# **CITY OF NEWBURGH GAC TREATMENT SYSTEM AT WASHINGTON LAKE FILTRATION PLANT**

## **ADDENDUM No. 1**

**TO CONTRACT NOS. D010308, D010309, D010310, D010326**

**Arcadis CE, Inc.  
855 Route 146, Suite 210  
Clifton Park, NY 12065**

SK1-C17-ADD1

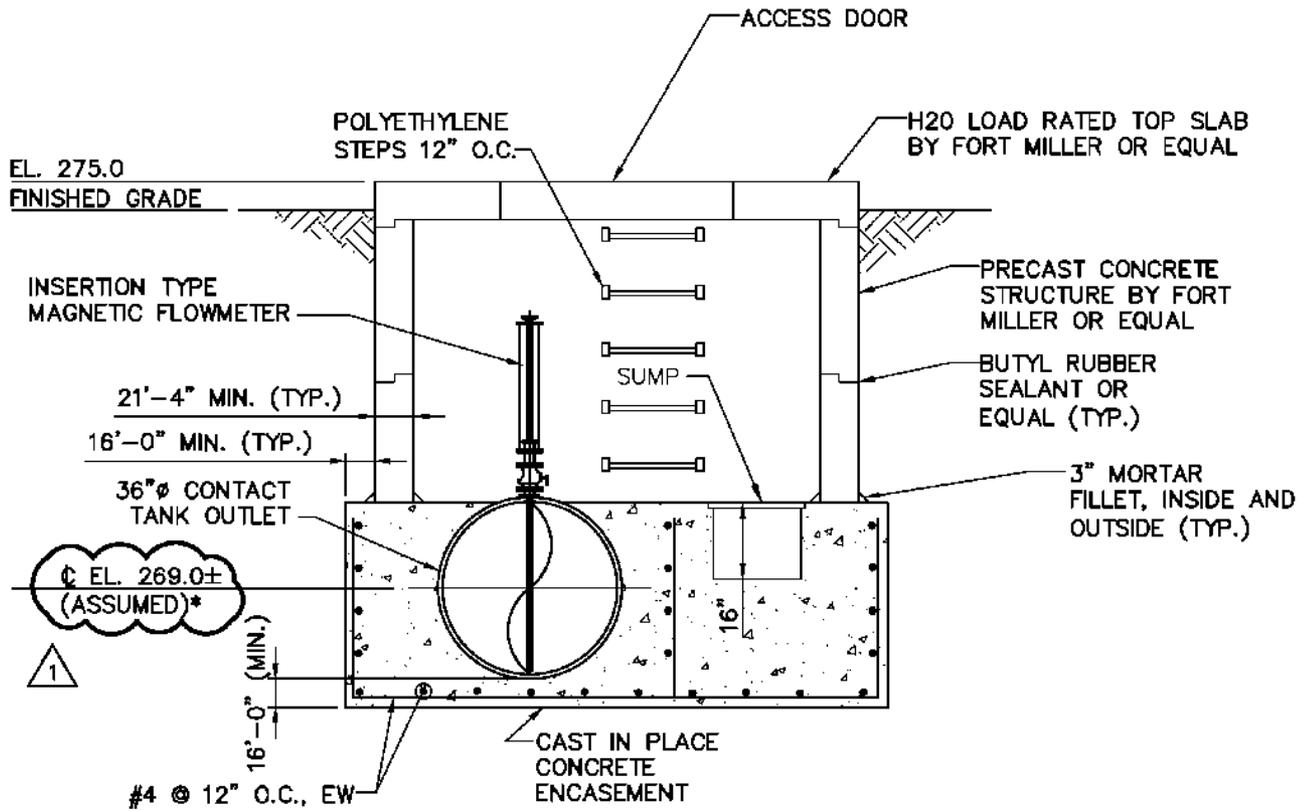
49. **Drawing C-17:** Add revision as shown on Figure SK1-C17-ADD1 as attached.
50. **Drawing C-17:** Add revision as shown on Figure SK2-C17-ADD1 as attached.

<p>Design &amp; Consultancy for natural and built assets</p>	<p>CITY OF NEWBURGH</p> <p><b>GAC TREATMENT SYSTEM AT WASHINGTON LAKE FILTRATION PLANT</b></p>	<p>MECHANICAL</p> <p><b>GAC TREATMENT BUILDING SECTIONS I</b></p> <p>NOT TO SCALE</p>	<p>NOVEMBER 2016</p>
			<p><b>SK3-M03-ADD1</b></p>

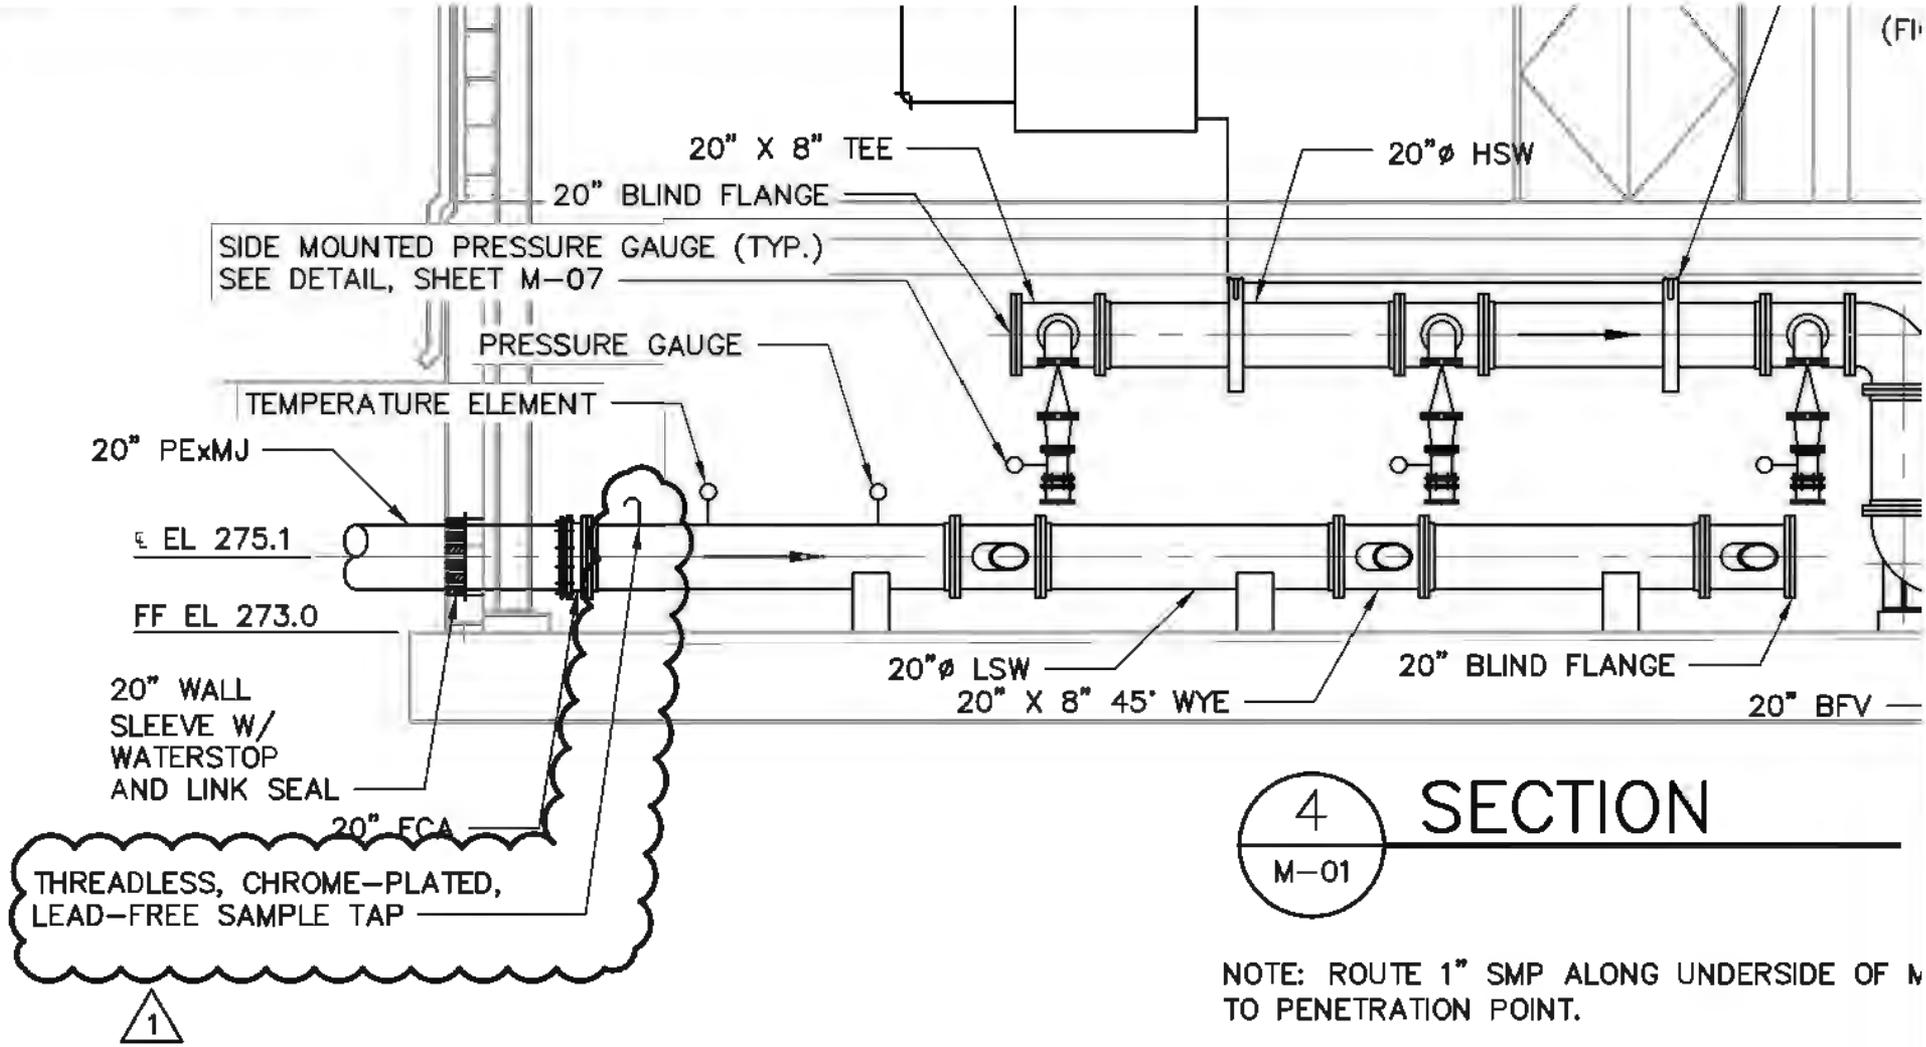
57. **Drawing M-03:** Add revision as shown on Figure SK3-M03-ADD1 as attached.
58. **Drawing M-04:** Add revision as shown on Figure SK1-M04-ADD1 as attached.

<p>Design &amp; Consultancy for natural and built assets</p>	<p>CITY OF NEWBURGH</p> <p>GAC TREATMENT SYSTEM AT WASHINGTON LAKE FILTRATION PLANT</p>	<p>HVAC</p> <p>MEZZANINE PLAN</p> <p>SCALE: 1" = 1'-0"</p>	<p>NOVEMBER 2016</p> <p>SK1-H03-ADD1</p>
---	---	--	--

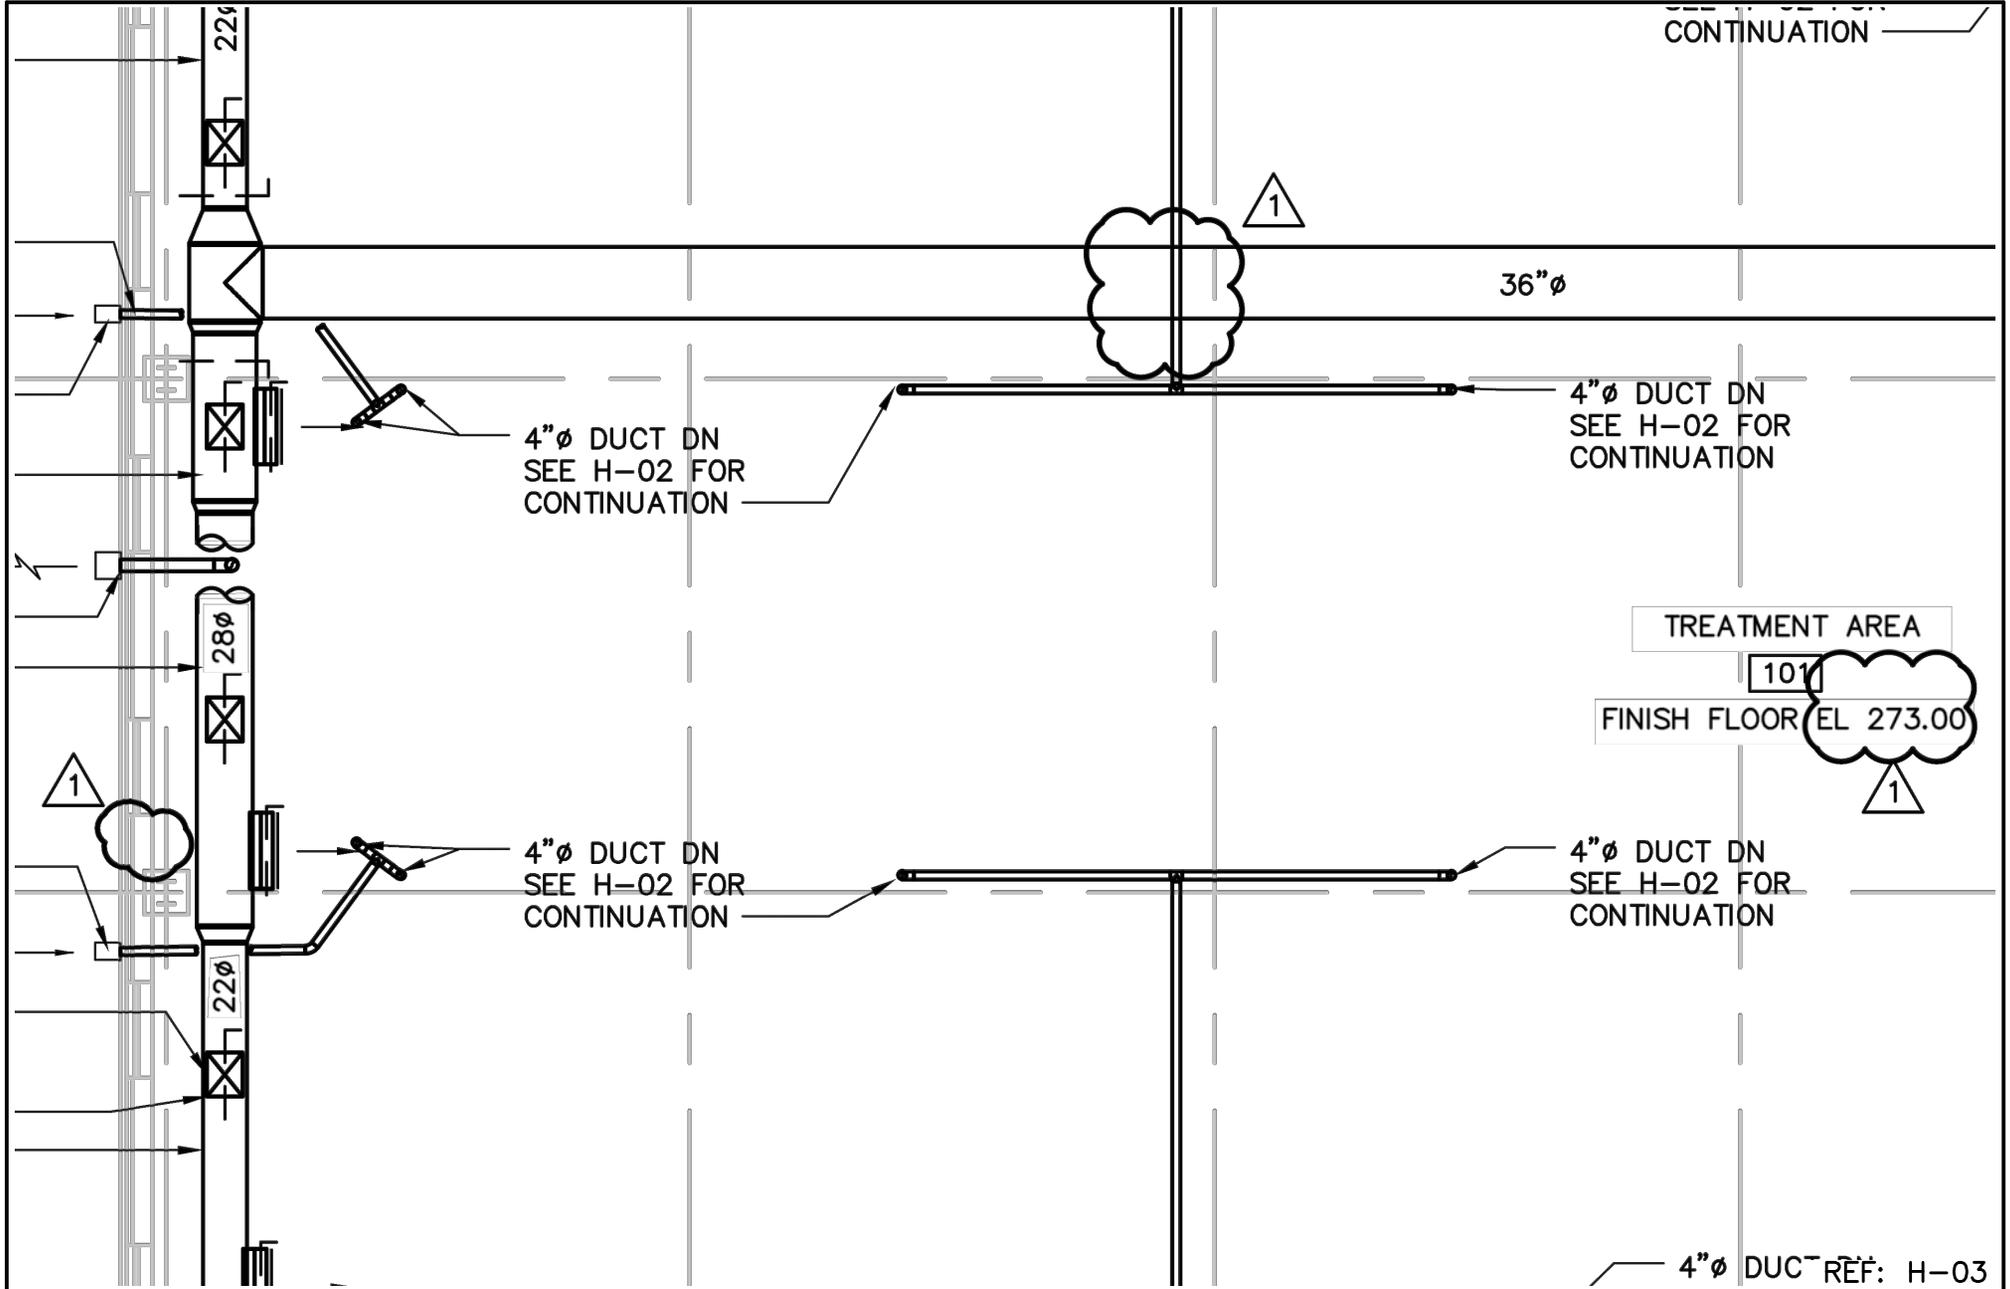
63. **Drawing H-03:** Add revision as shown on Figure SK1-H03-ADD1 as attached.
64. **Drawing H-03:** Add revision as shown on Figure SK2-H03-ADD1 as attached.
